**ADDENDUM
NO. 4**

October 18, 2024

**Whiteland High School Ph 2: Café Kitchen Band Choir Auditorium
300 E. Main Street
Whiteland, IN 46184**

MECHANICAL MEZZANINE DEMOLITION PLAN

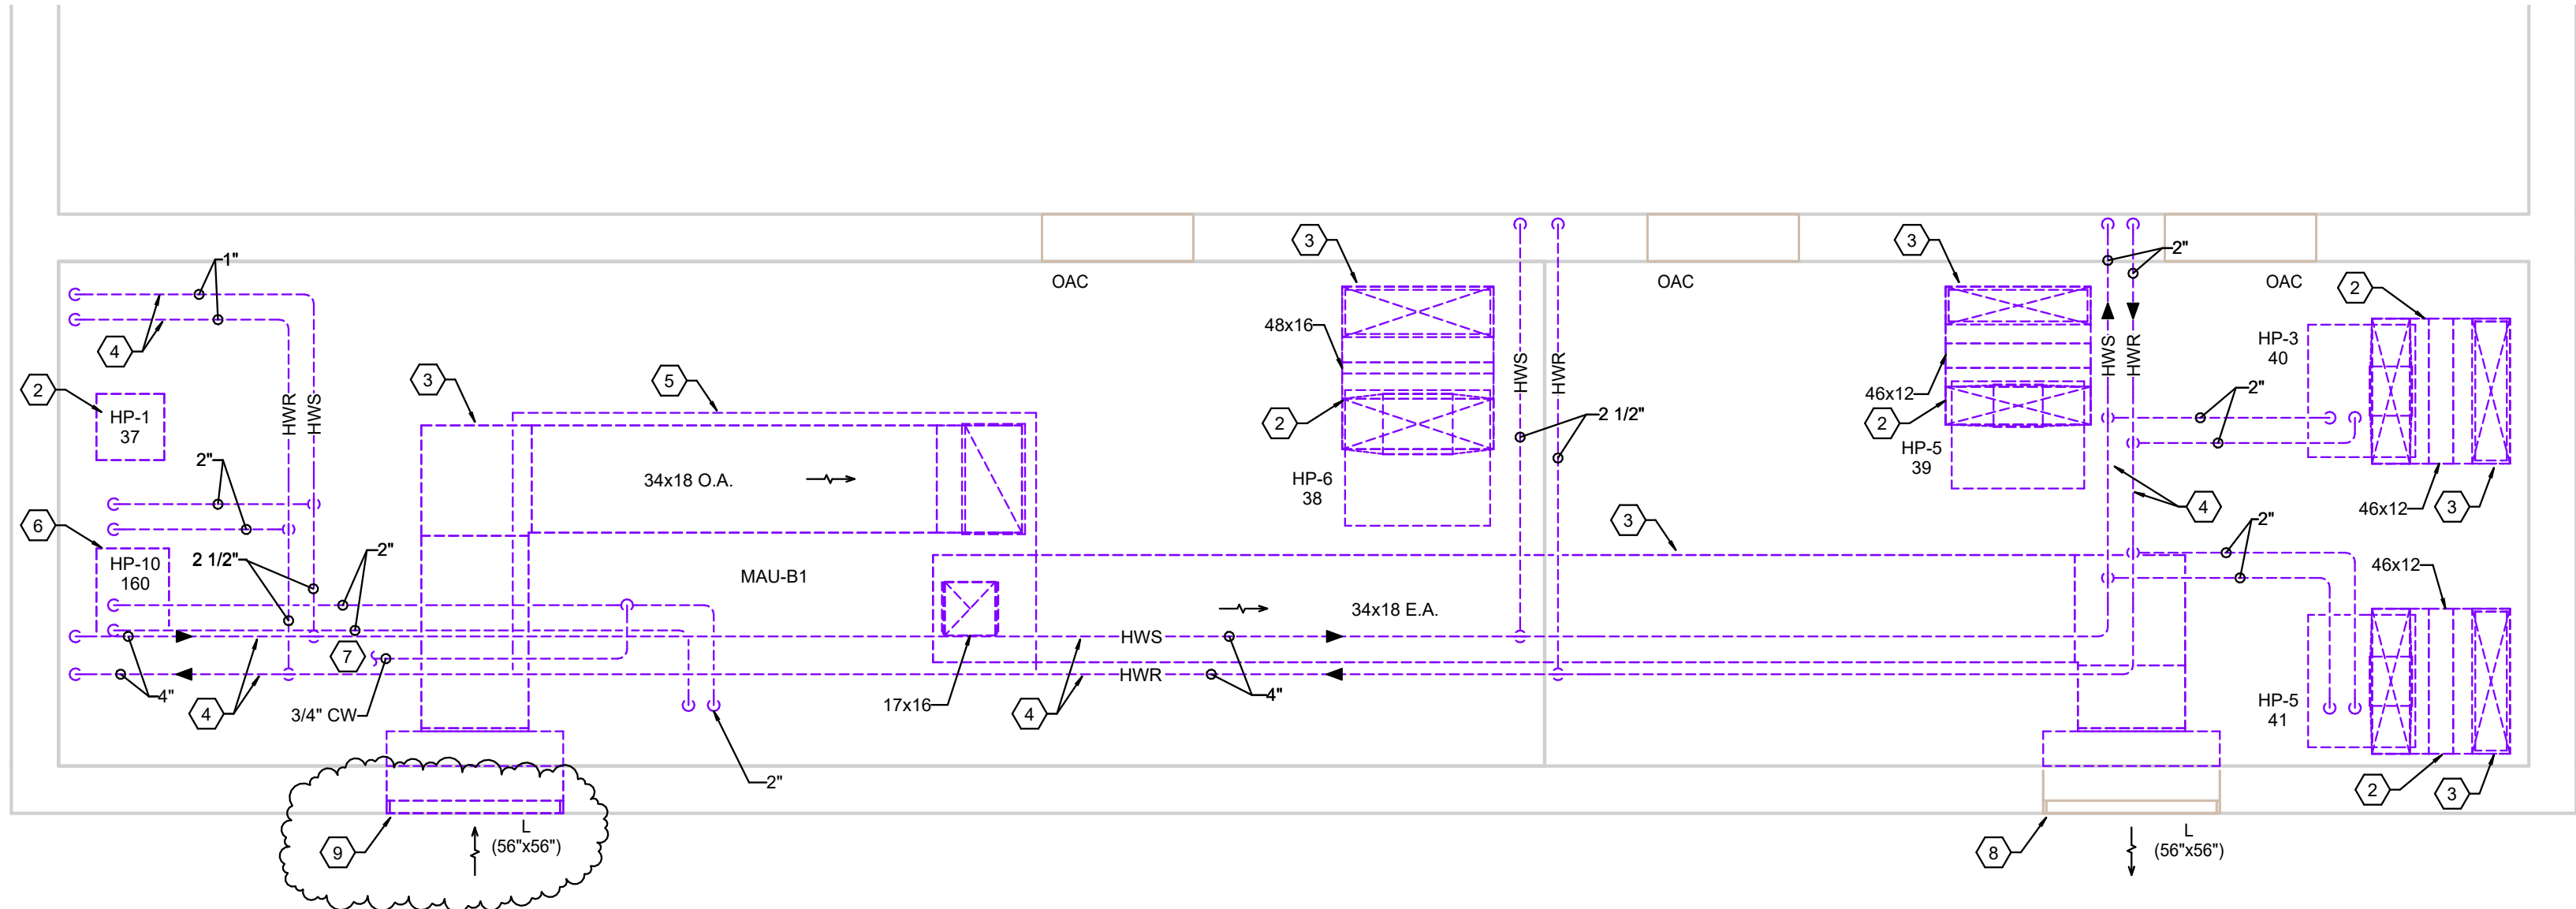
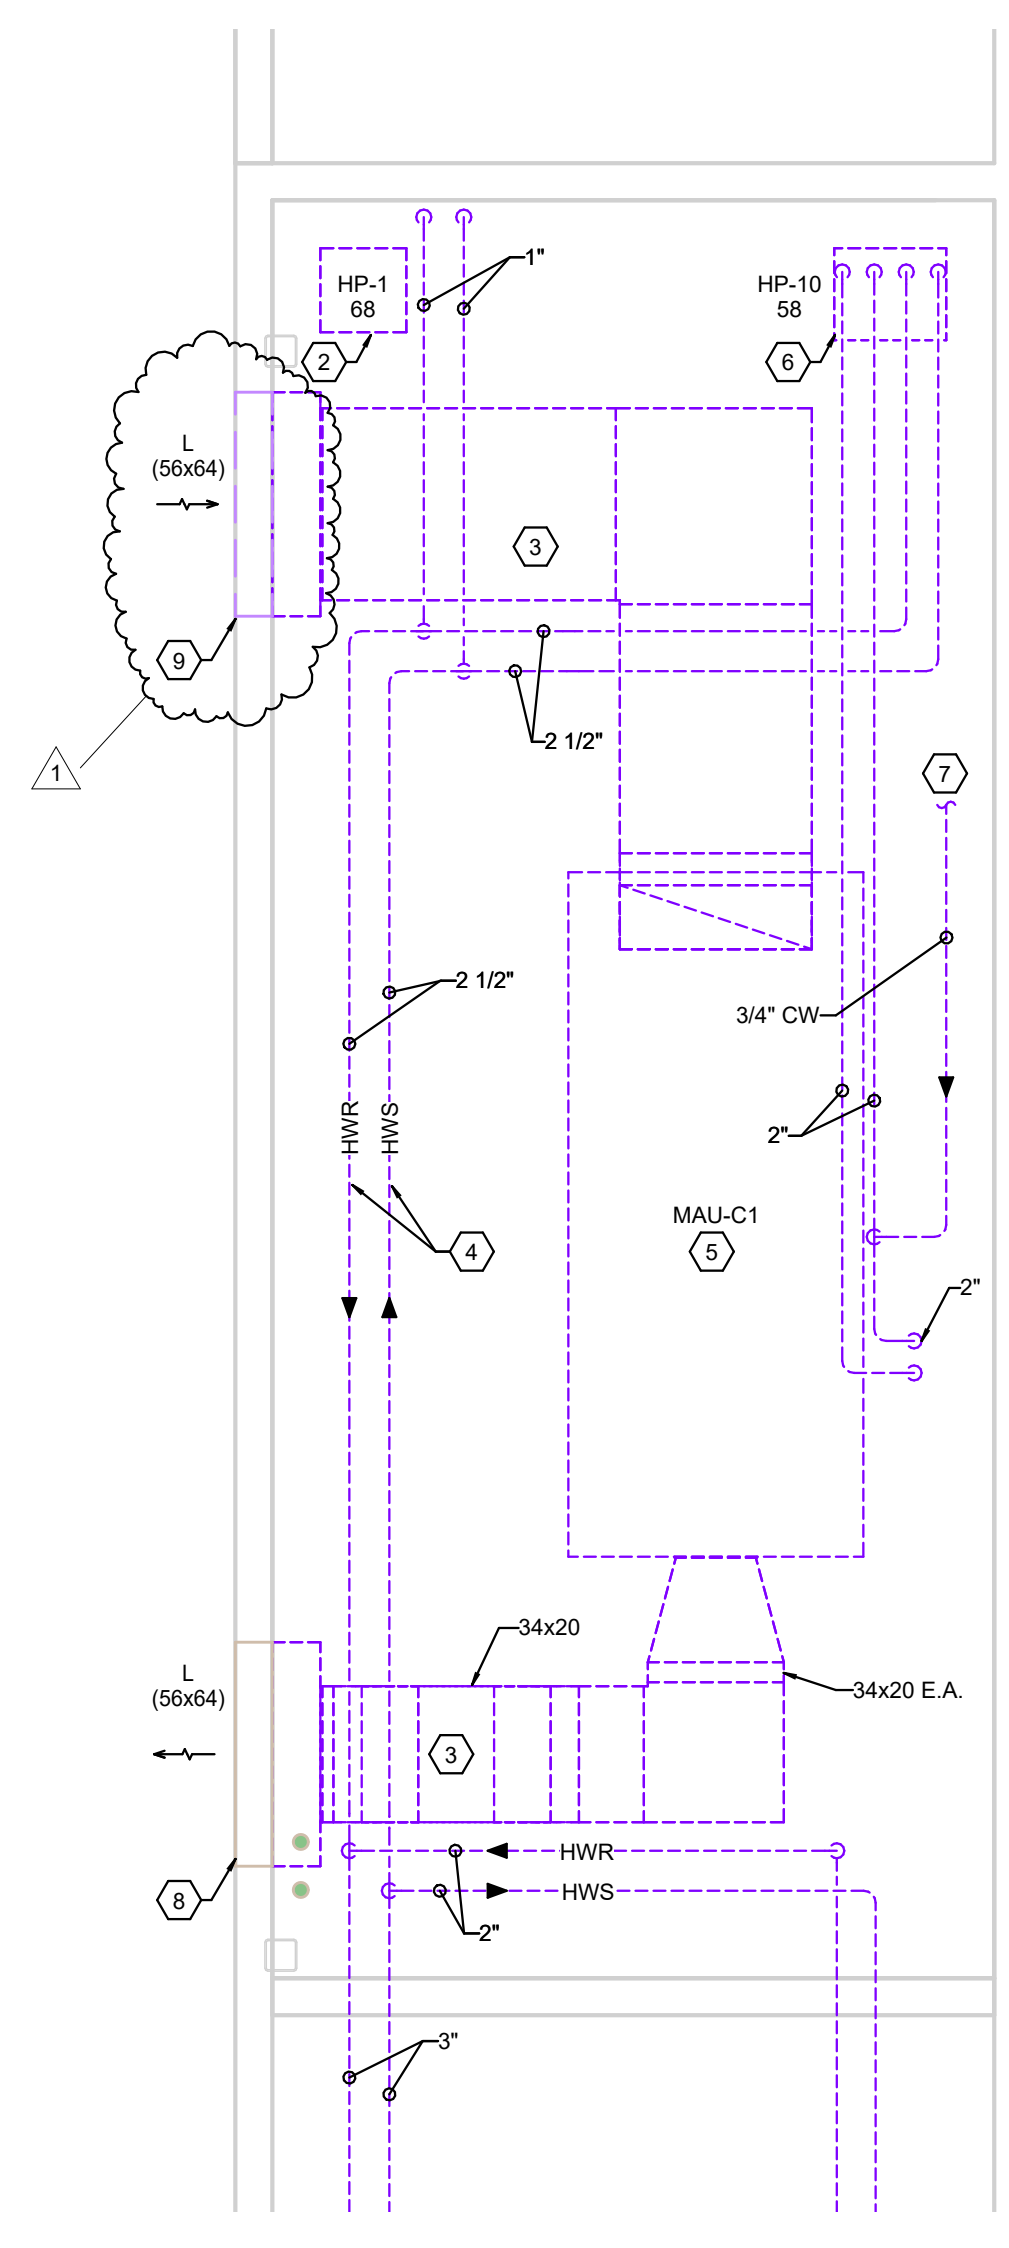
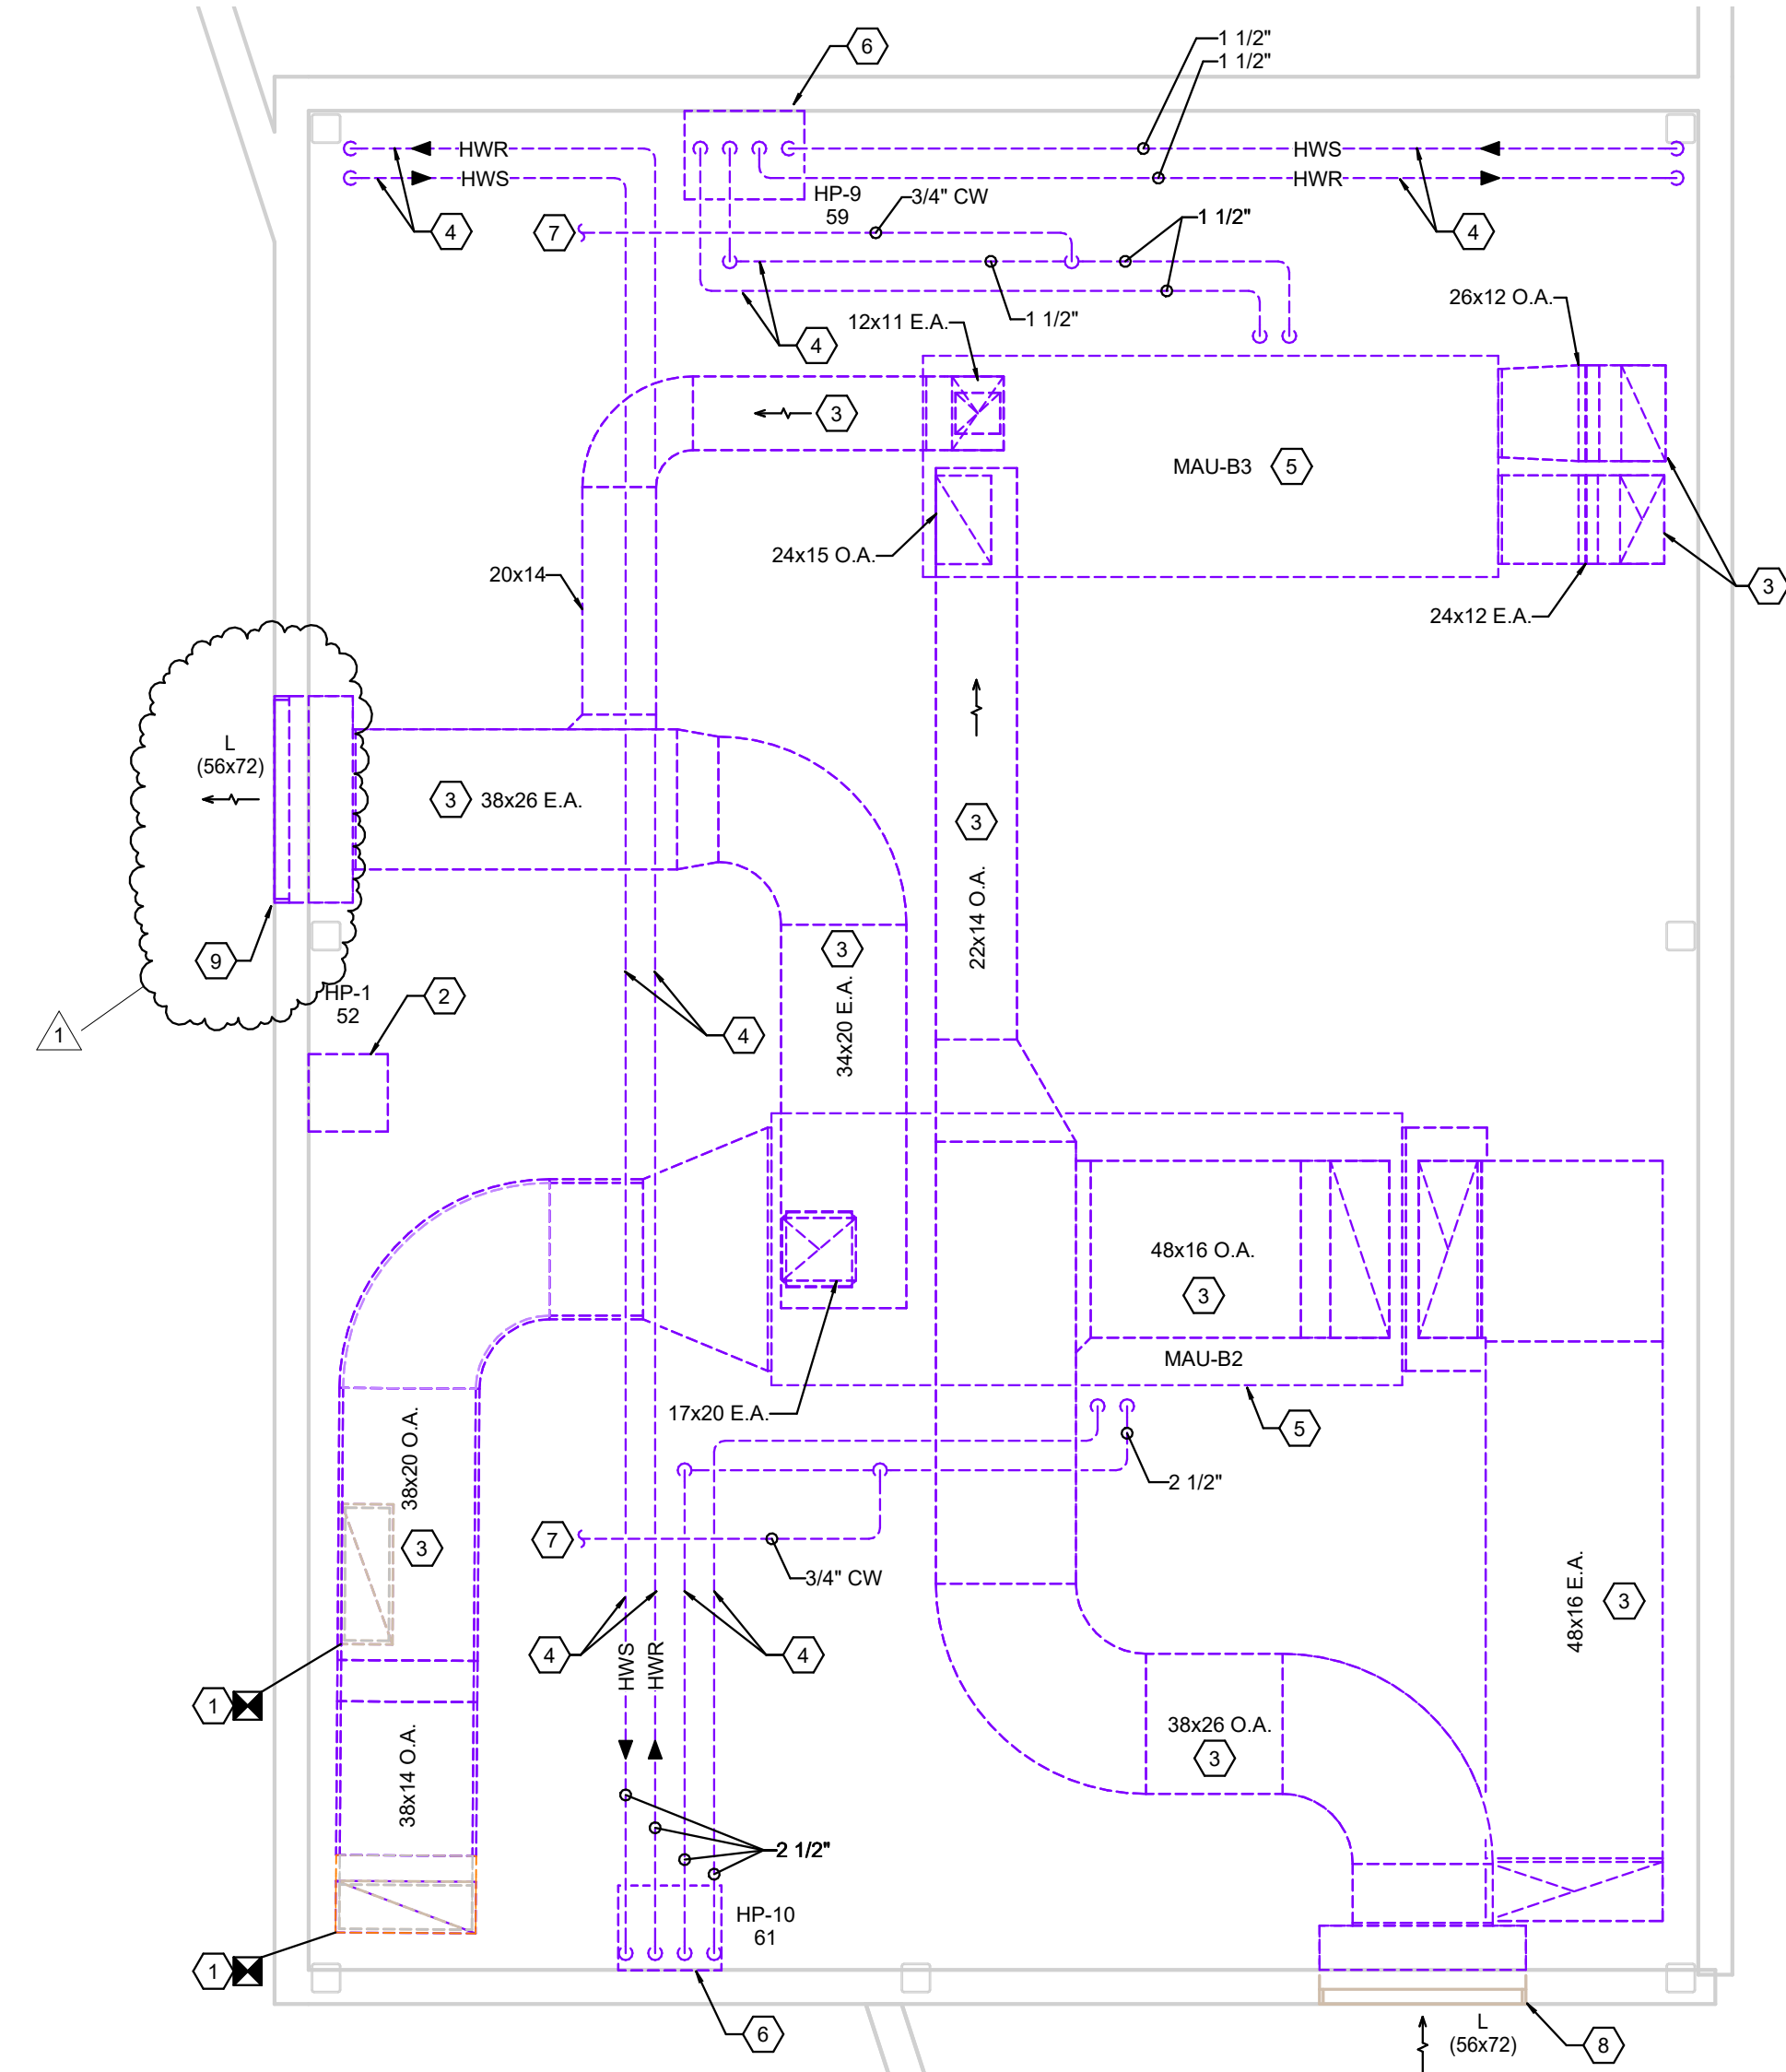
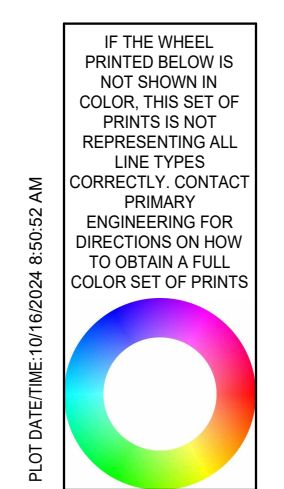
9. DRAWING SHEET MD103.

- a. Add demolition of existing louvers. Refer to attached drawing revision.

ARCHITECTURAL LIGHTING - TITLE SHEET

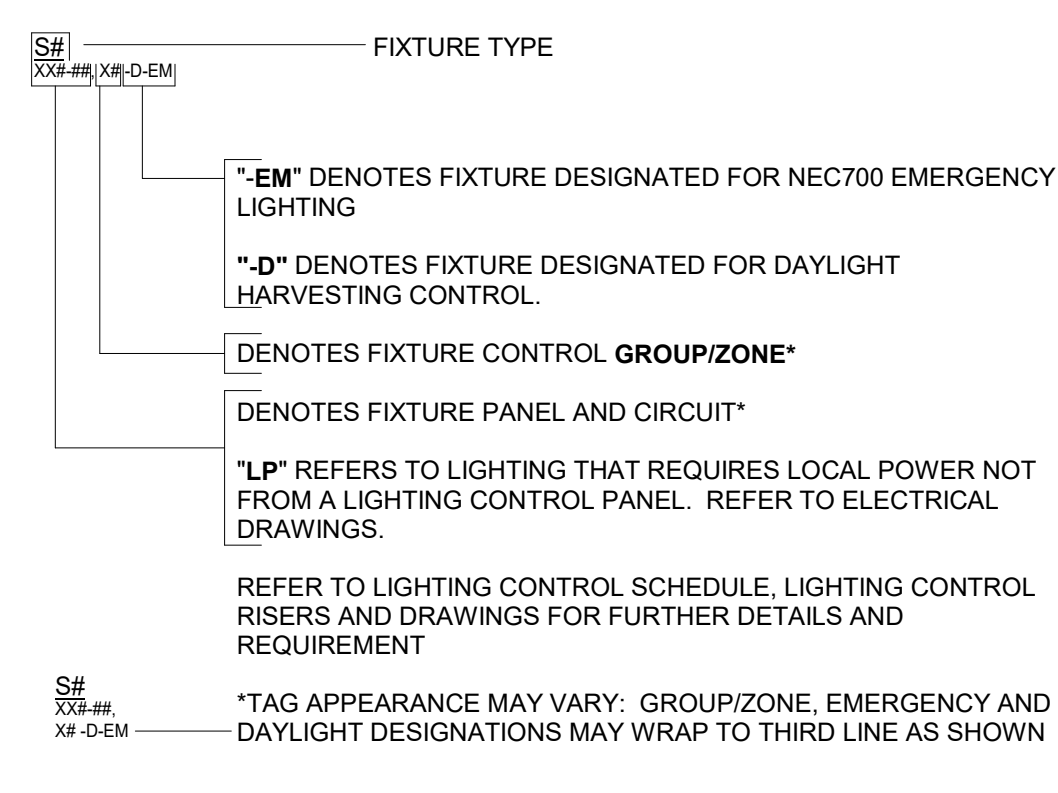
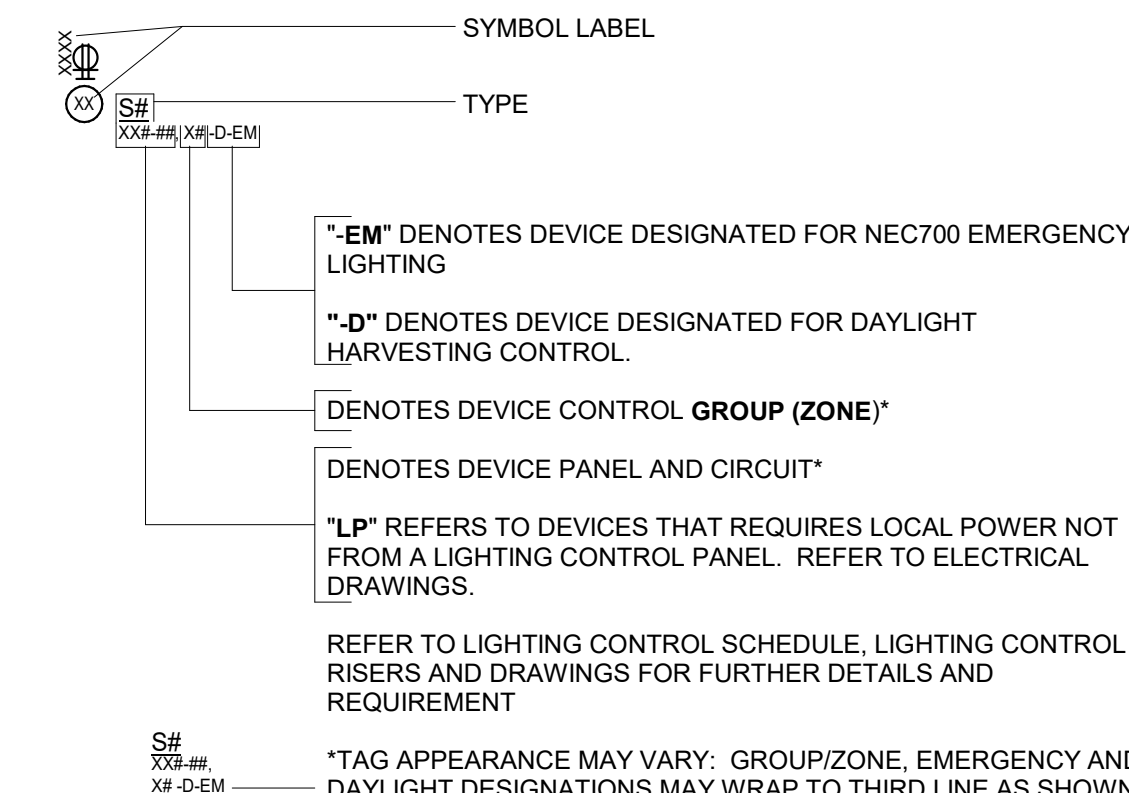
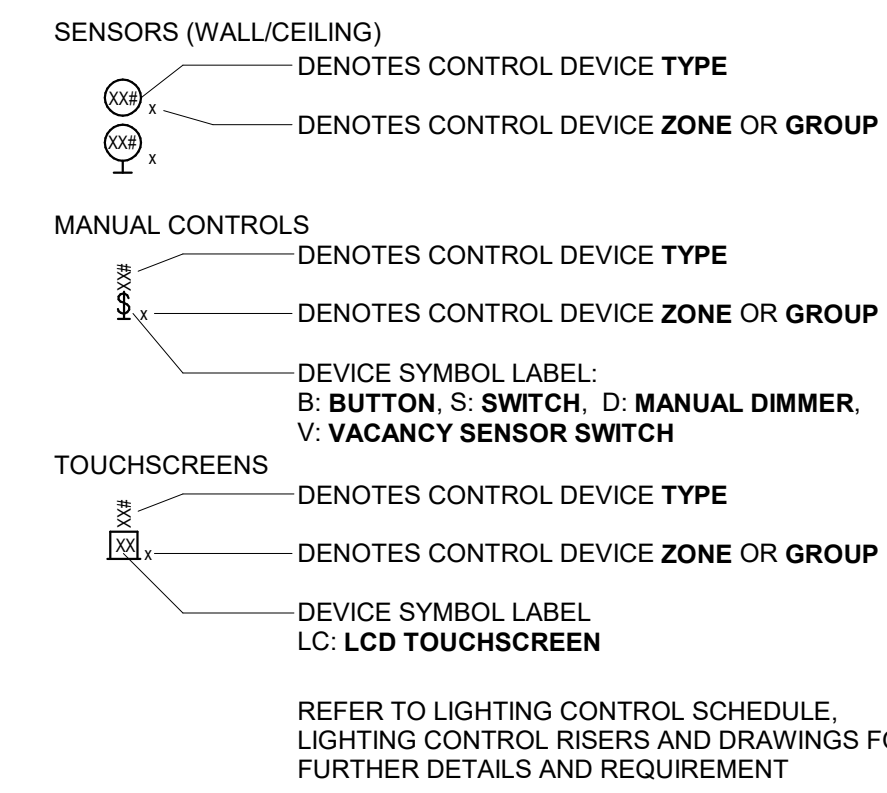
12. Sheet AL000 - ARCHITECTURAL LIGHTING - TITLE SHEET: Refer to clouded area of revised sheet for changes:

- a. Update Sheet List Revision and Date
